Subject: TeamPoS 3600 USB Error Message

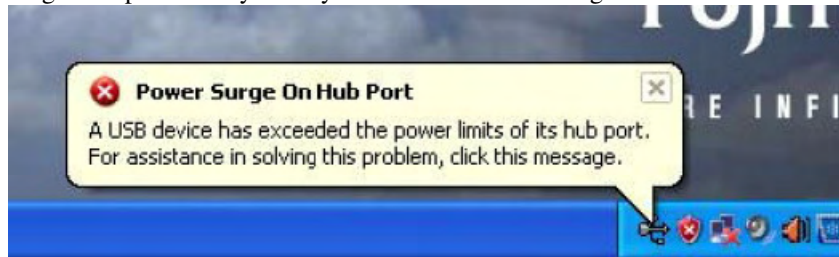
A Windows pop-up error that indicates one of the USB ports detected an Over-Current condition could be displayed shortly after startup or during operation. This is a false error. All ports are fully functional and there is no impact to the terminal operation. The error can be cleared (though could show up again) or not. Depending on the customers application, screen overlays, and security settings the operator may or may not even see this message if it occurred.

If the error should be seen in the field and causes impact, the motherboard (11003001) should be replaced with a Rev2 or later board. The removed board should be returned for warranty repair/replacement. The solution is the addition of 4 resistors to the motherboard. This changes the motherboard revision from Rev1 to Rev2.

Below are illustrations of the Motherboard identifying the 4 components that are added to correct this error. Rev1 boards do not have these components, Rev2 boards have all 4 components installed. This information is provided for Informational and Identification purposes only. Field changes or rework to the motherboard is NOT implied or authorized.
